Front Passenger Interior Door Assist Grip Cover Loose

REVISION NOTICE

July 31, 2013 Rev1:

Figure 3.

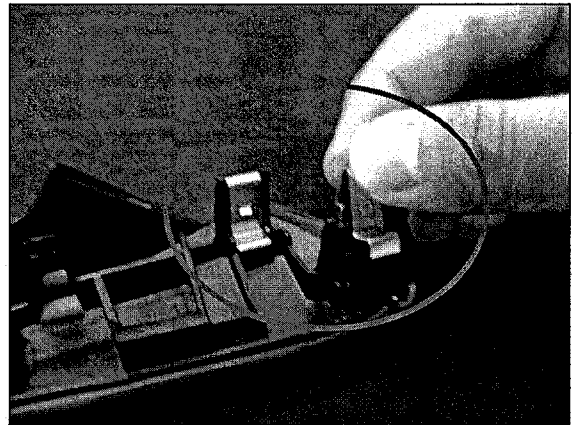
3. On the new part, install the 2 retainers on the plastic holders as shown.

Figure 4.

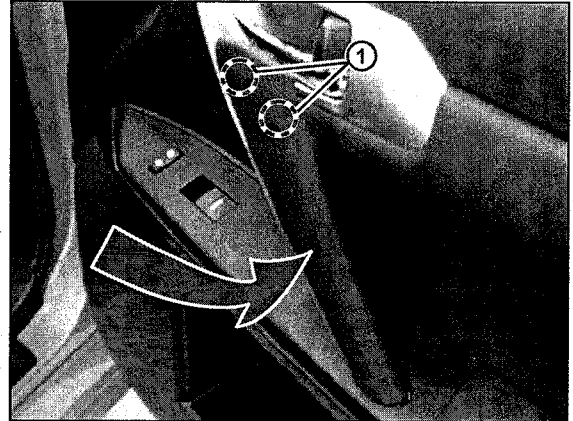
4. Install the assist grip cover.

5. Confirm the click sound from the two clips when the assist grip cover is installed in the door trim panel.
